**CONTRACT DOCUMENTS & TECHNICAL SPECIFICATIONS & PLANS
ADDENDUM No. 1**

**CAPE HENLOPEN STATE PARK
PARK ROAD - COLLEGE OF EARTH, OCEAN, & ENVIRONMENT
CONTRACT NO. 2013-CH-400
June 14, 2013**

SHEET NO. C-20 TOTAL SHTS. X

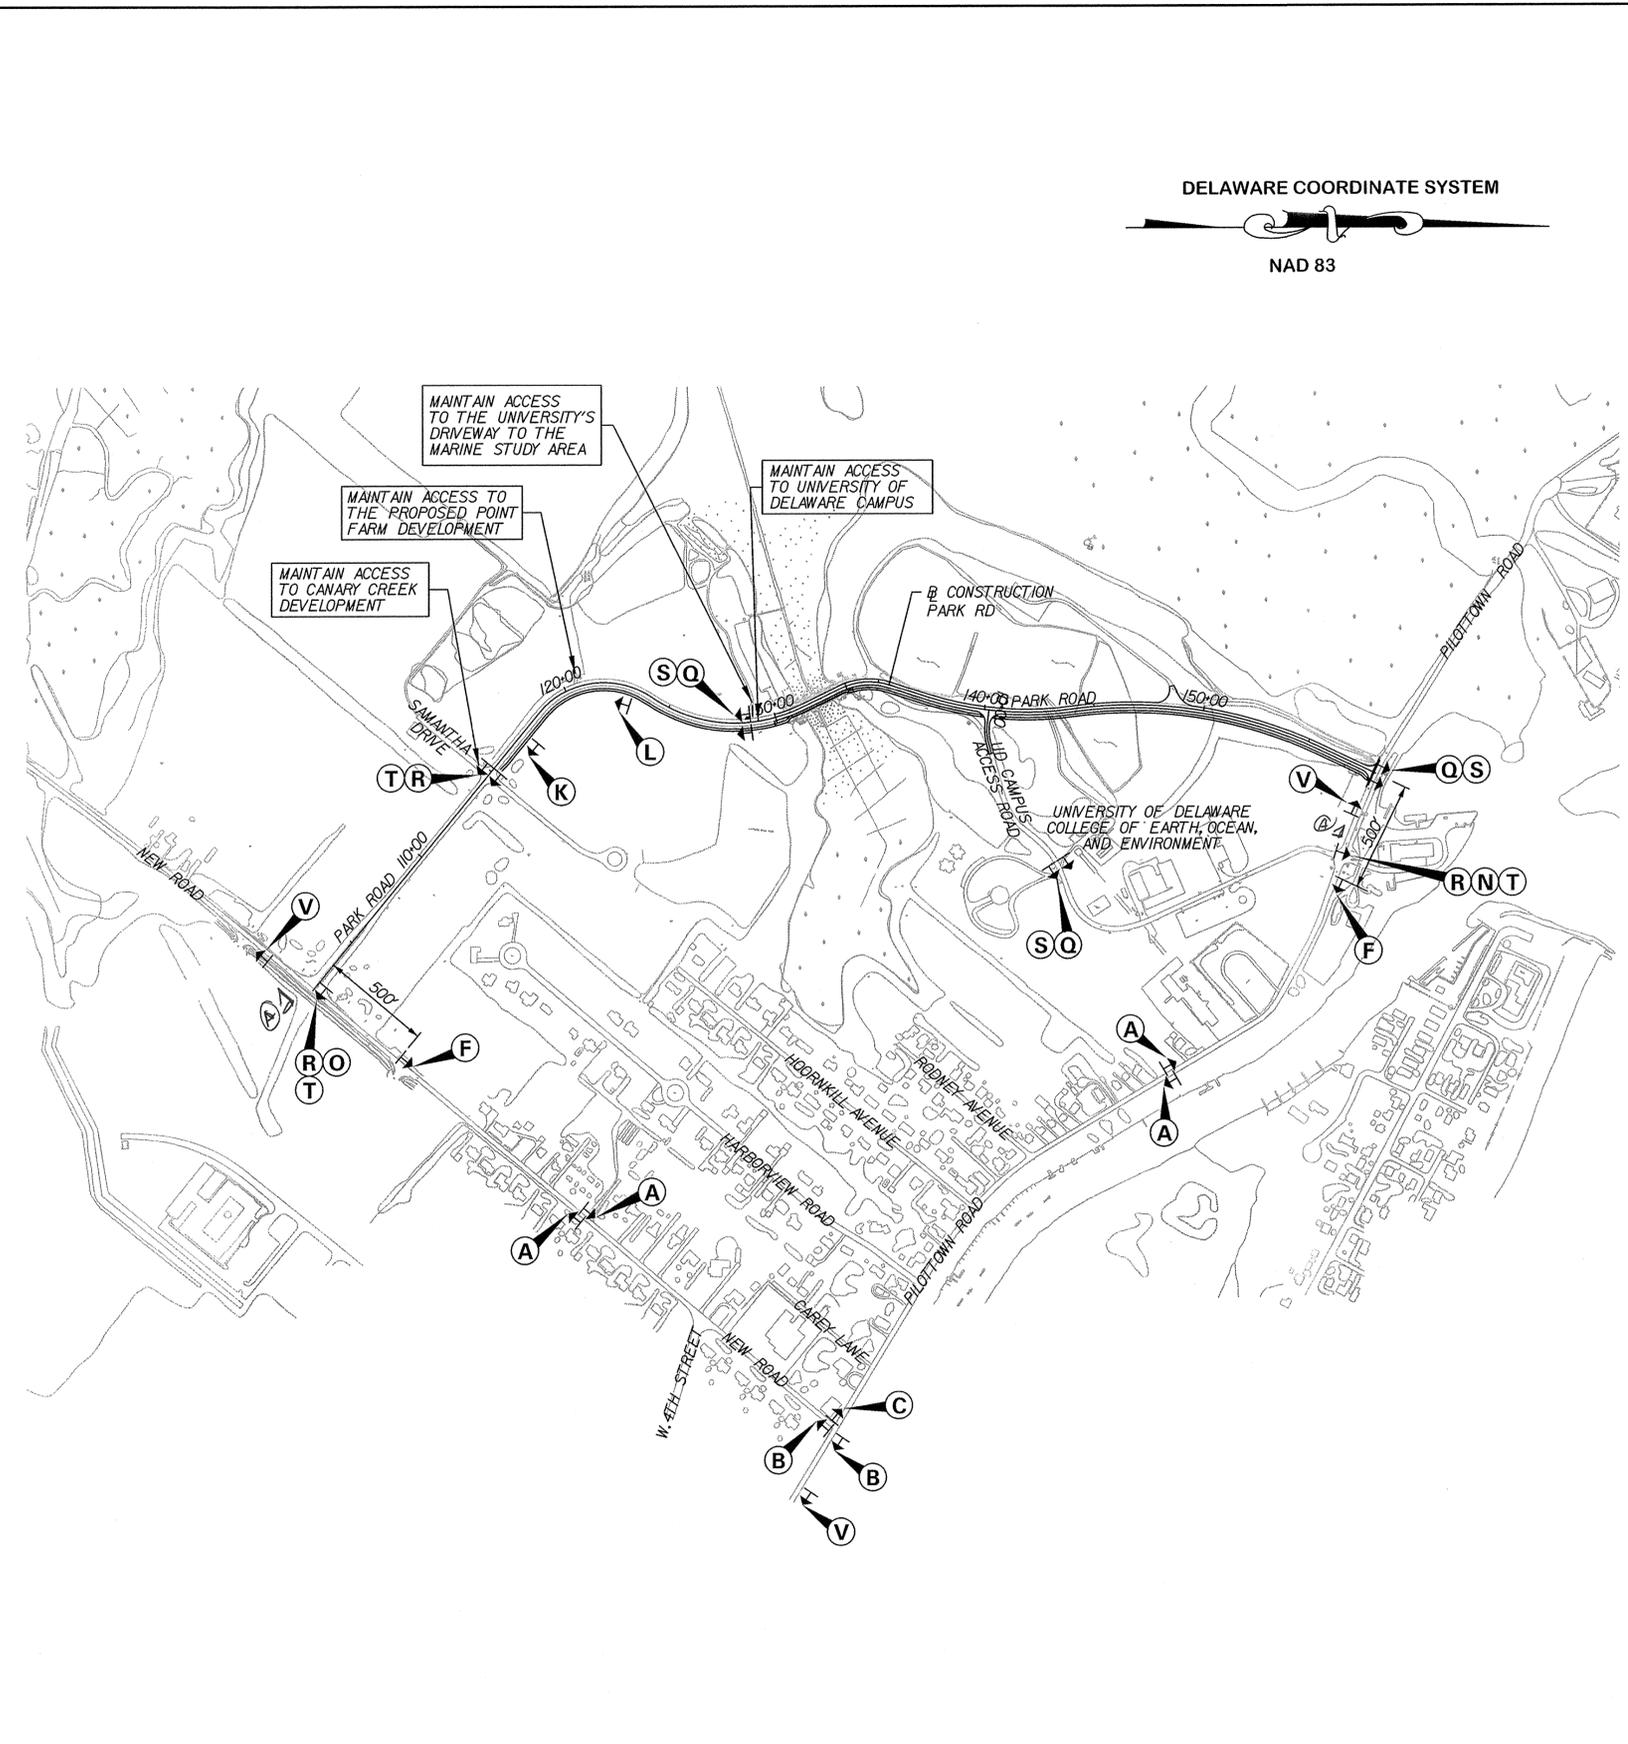
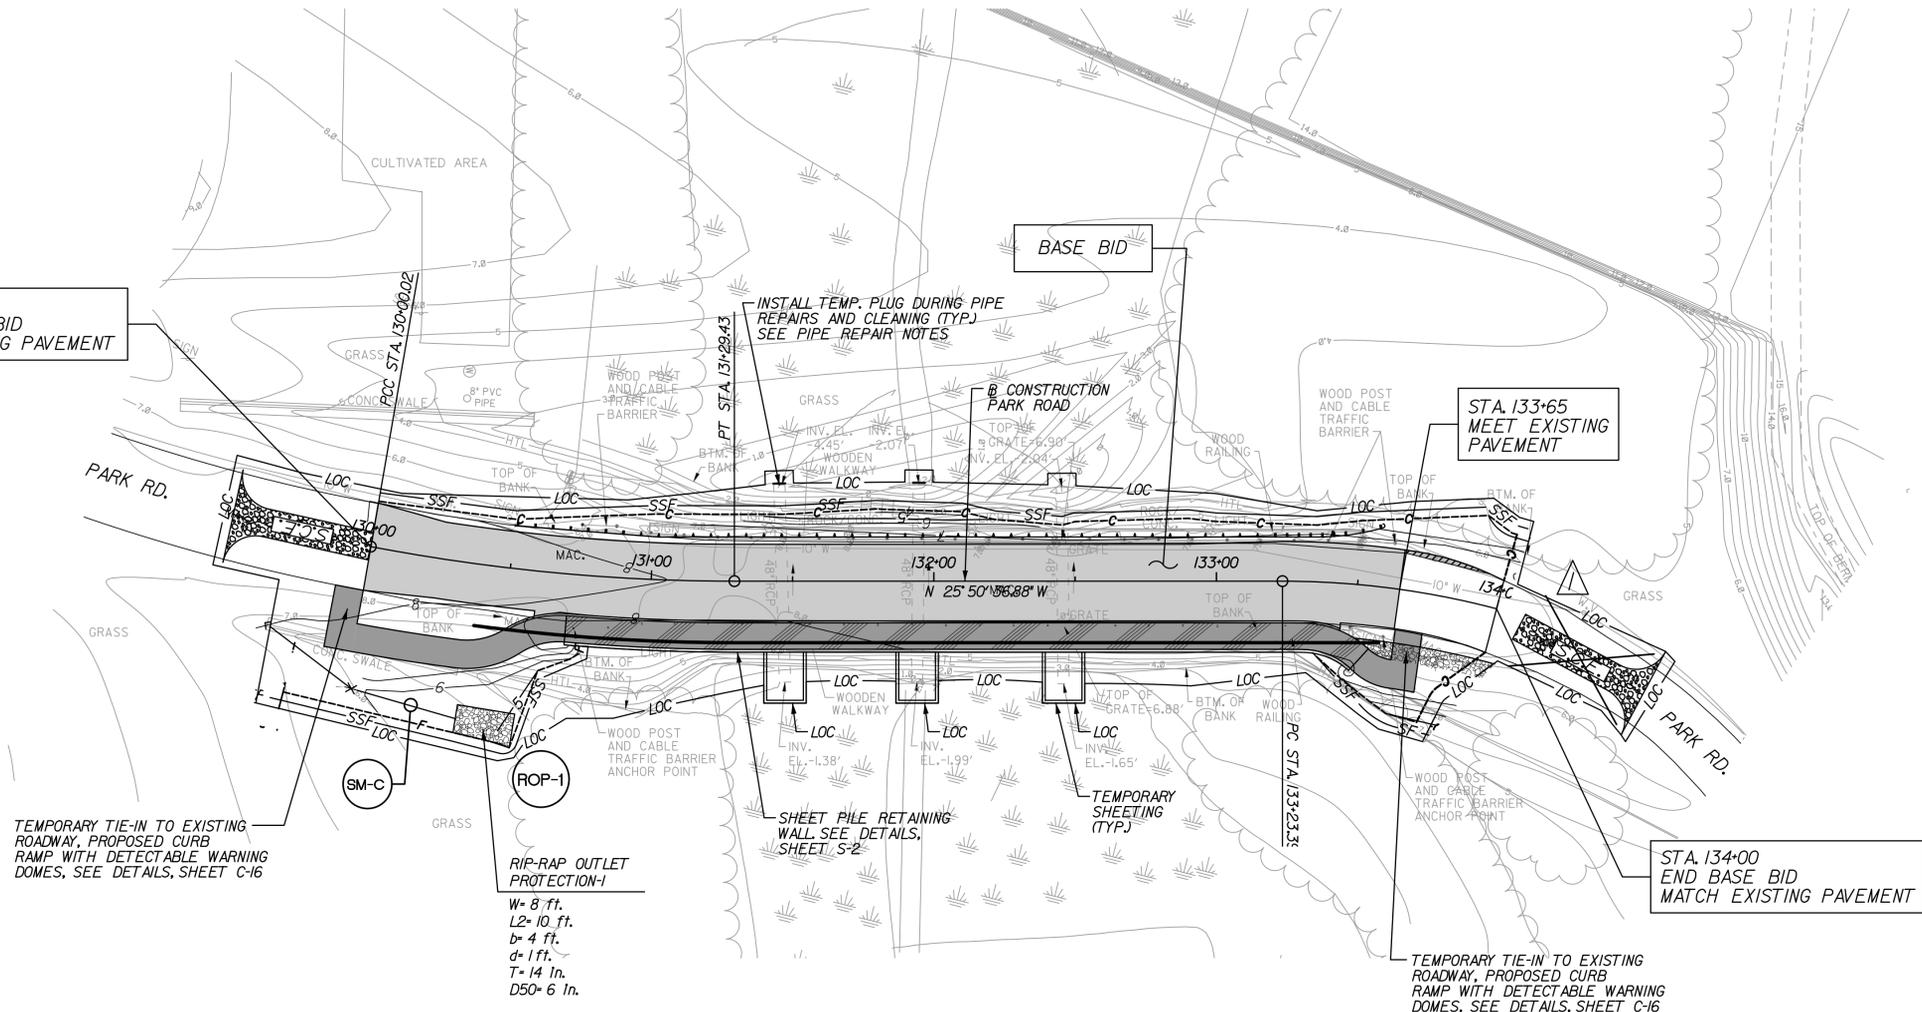
Sheet No. C20 - Signature of Chief Safety Officer

DESIGNED BY: RKK
DRAWN BY: RKK
BUILDING NO.: N/A
DATE: 5/3/13
SCALE: 1"=30'
SHEET NO.: ES-01
PARKS PROJECT #: CH-49
CONTRACT #: 2013-CH-400

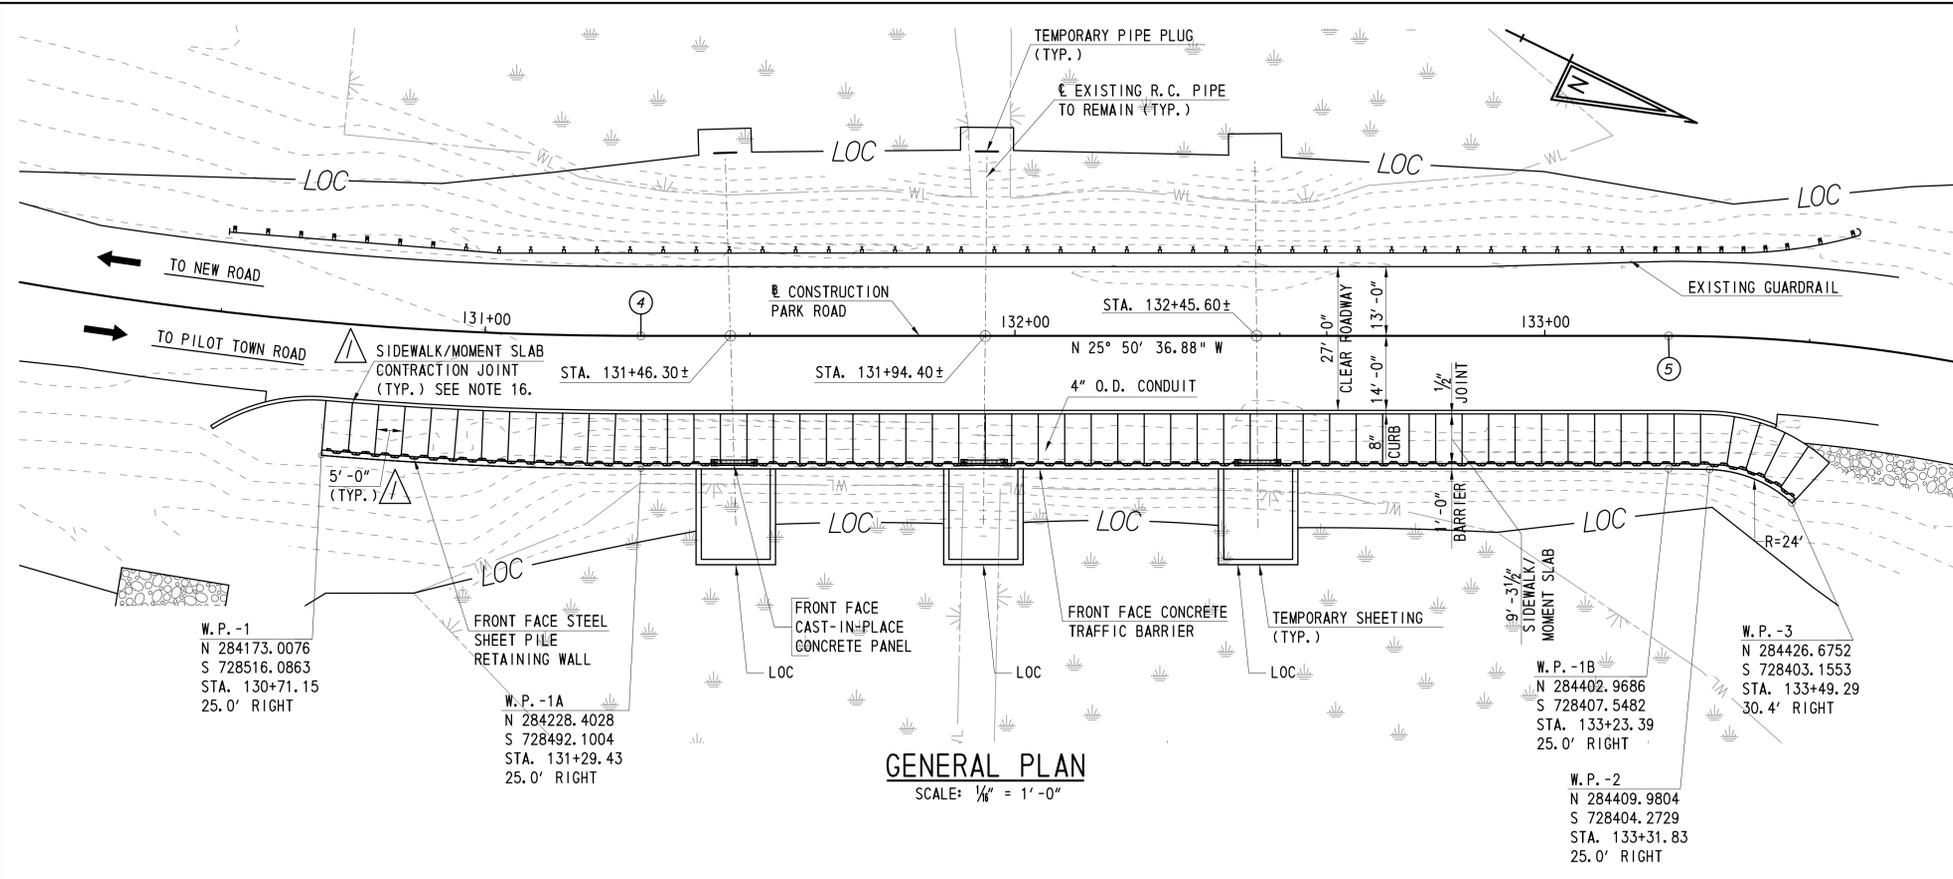
Sheet No. ES-01 - DELETE the S.C.E. Device at North End of Causeway.

DATE: 6.13.13
DESCRIPTION: DELETED ESC DEVICE

DESIGNED BY: RKK
DRAWN BY: RKK
BUILDING NO.: N/A
DATE: 5/3/13
SCALE: AS NOTED
SHEET NO.: S-1
PARKS PROJECT #: CH-49
CONTRACT #: 2013-CH-400

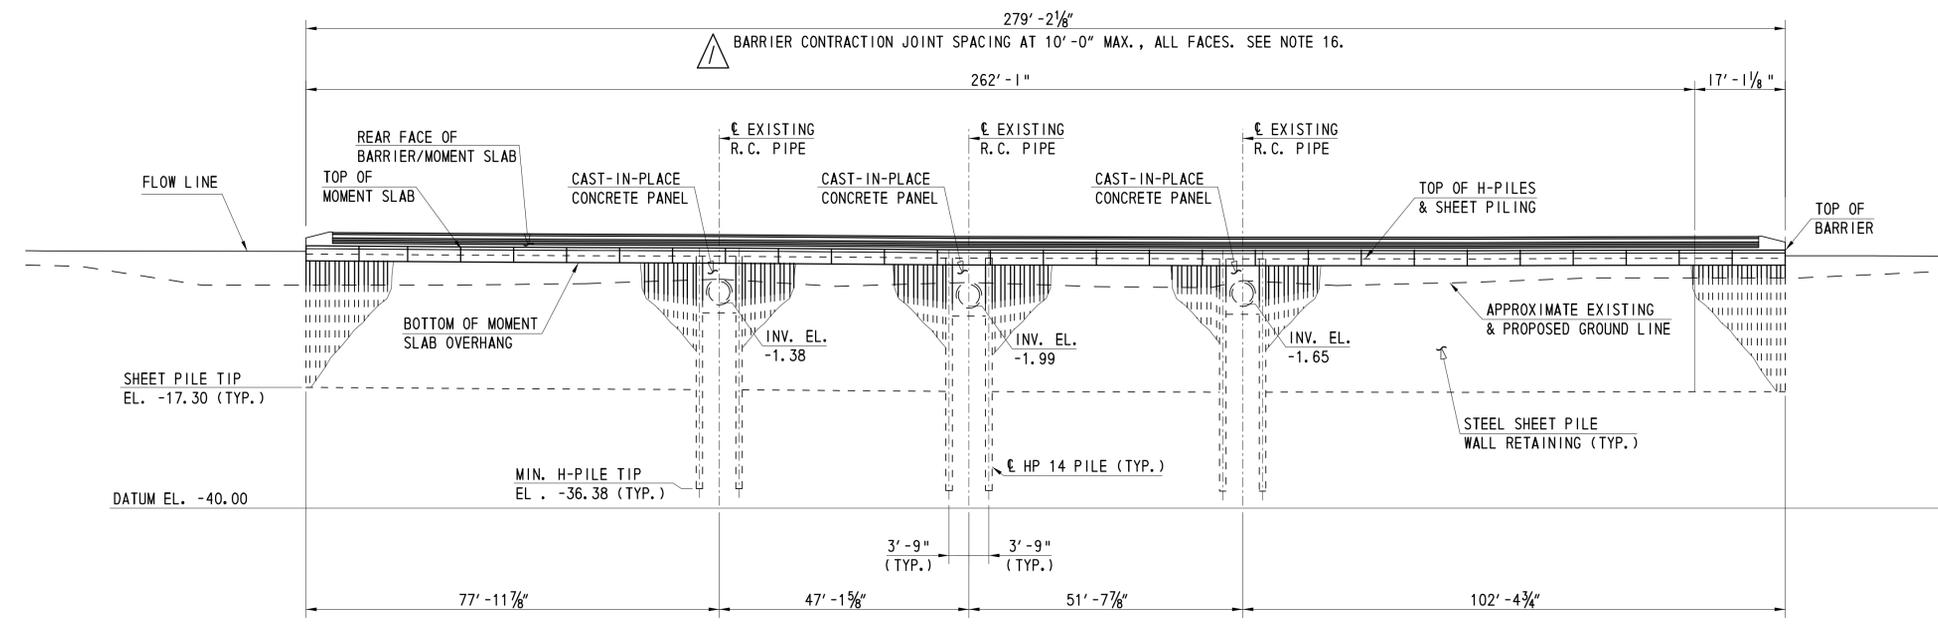
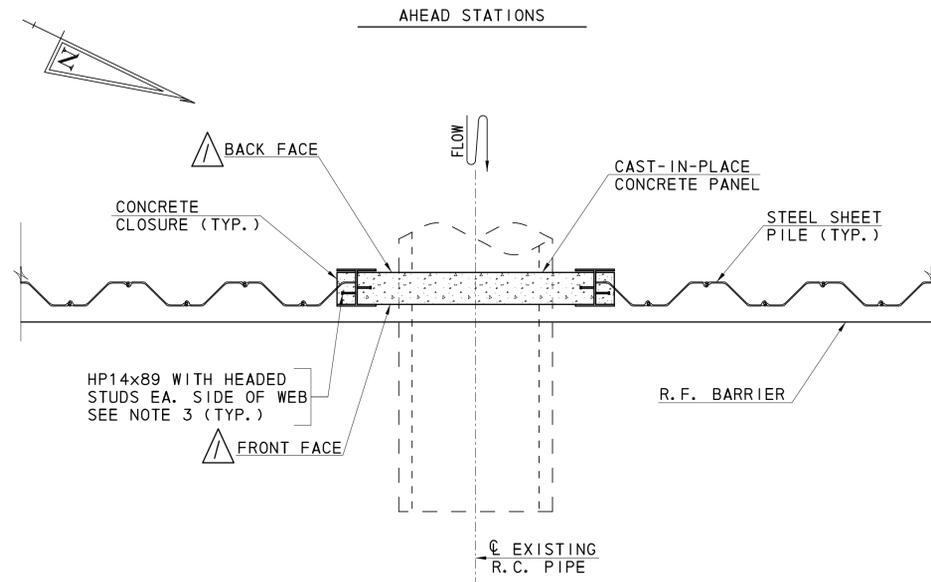
Sheet No. S-1 - Joint Spacing for Sidewalk/Moment slab
ADD Notes 16, 17, 18

- THE SIDEWALK/MOMENT SLAB SHALL BE MARKED INTO RECTANGULAR SLABS BY SCORING, 1/2" MINIMUM, WITH APPROVED EDGING TOOLS. THE SURFACE EDGES OF EACH SLAB SHALL BE ROUNDED TO A 1/4" RADIUS. THE CONTRACTOR SHALL SUBMIT SHOP DRAWINGS SHOWING CONTRACTION JOINT LAYOUT AND SPACING.

- SILICONE RUBBER JOINT SEALANT SHALL CONFORM TO ASTM D5893.
- WATERSTOPS SHALL BE POLYVINYL CHLORIDE (PVC) COMPOUNDED AS NECESSARY TO CONFORM TO THE REQUIREMENTS OF U.S. ARMY CORPS OF ENGINEERS SPECIFICATION CDR-C57S. NO RECLAIMED PVC FROM ANY SOURCES SHALL BE INCORPORATED IN THE COMPOUNDING. THE EXTRUDED MATERIAL SHALL BE DENSE, HOMOGENEOUS, AND FREE FROM POROSITY OR OTHER IMPERFECTIONS THAT COULD AFFECT ITS DURABILITY OR PERFORMANCE. THE CONTRACTOR SHALL SUBMIT SHOP DRAWINGS FOR THE WATERSTOP.

DESIGNED BY:	RKK
DRAWN BY:	RKK
BUILDING NO.:	N/A
DATE:	5/3/13
SCALE:	AS NOTED
SHEET NO.:	S-3
PARKS PROJECT #:	CH-49
CONTRACT #:	2013-CH-400

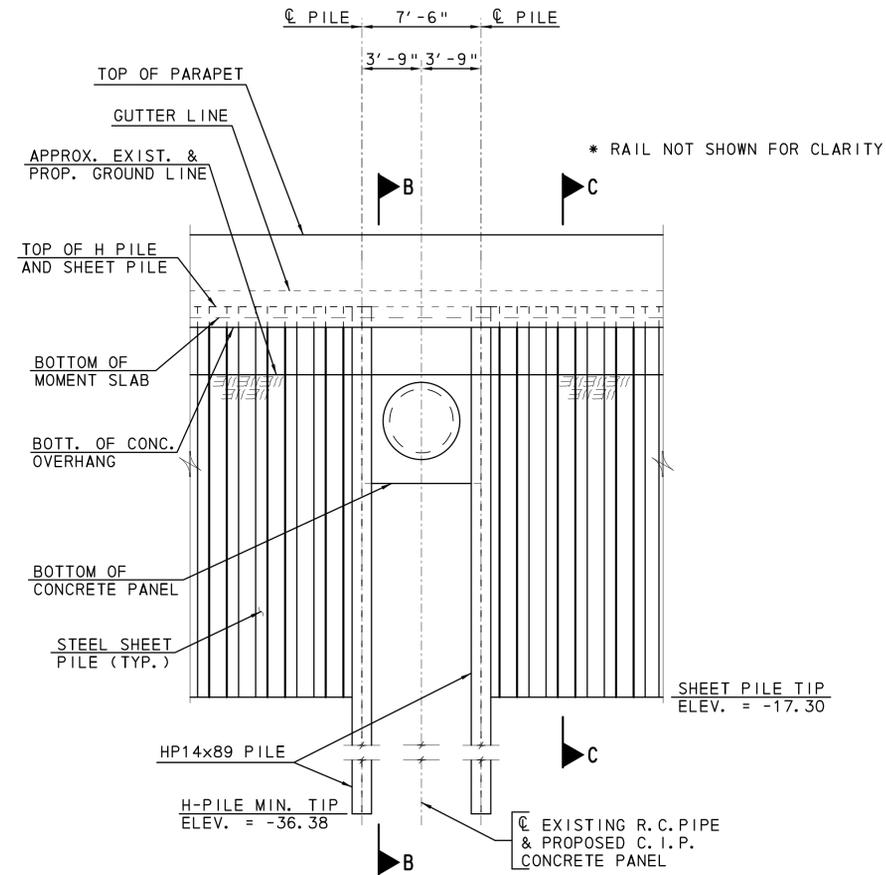
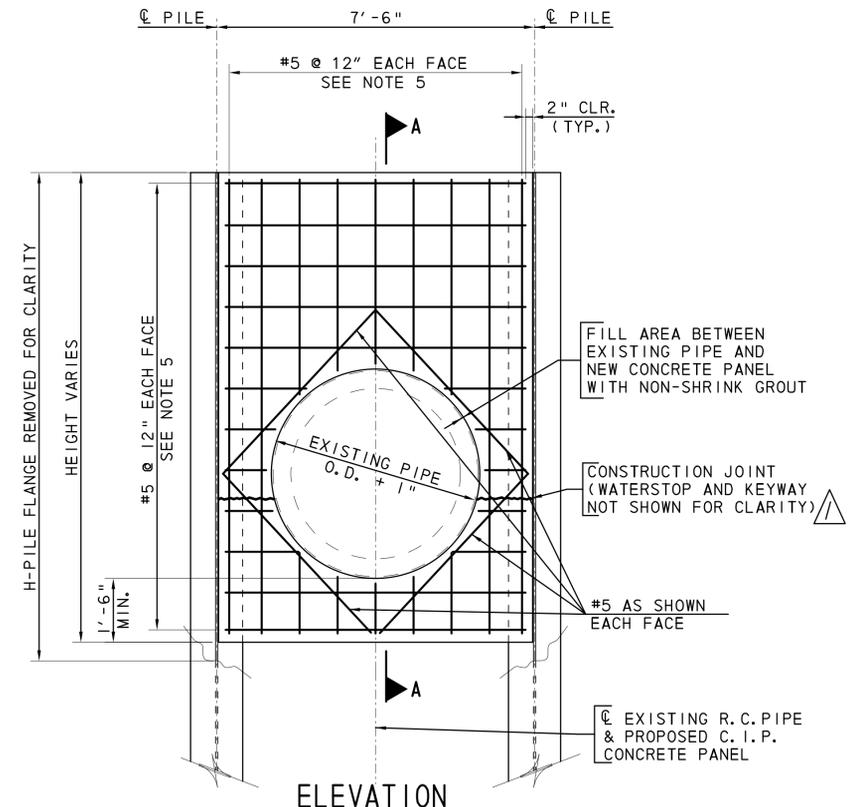
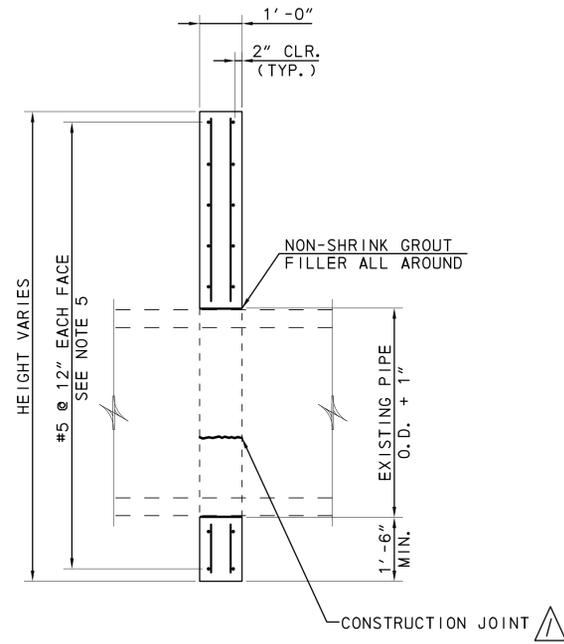
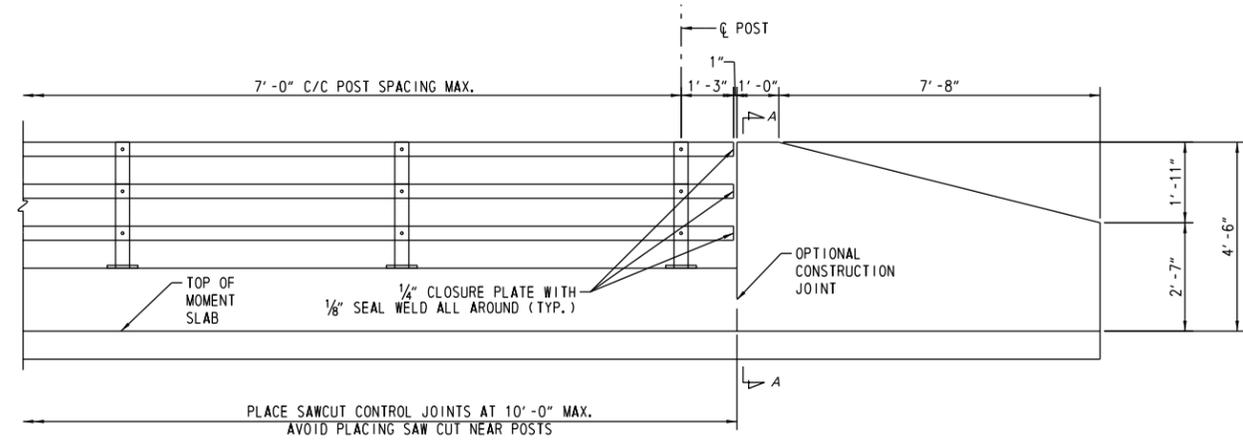
Sheet S-3 - Water Stop and Keyway

1. FORM BACK FACE AND PLACE REINFORCING.
2. FORM FRONT FACE TO CONSTRUCTION JOINT.
3. PLACE WATER STOP AT CONSTRUCTION JOINT.
4. PROVIDE 1"x3" KEY WAY AT CONSTRUCTION JOINT.
5. PLACE CONCRETE TO CONSTRUCTION JOINT.
6. CURE CONCRETE FOR 3-DAYS OR 60% F'C BEFORE REMOVING FORM.
7. PLACE REMAINING CONCRETE ABOVE CONSTRUCTION JOINT.
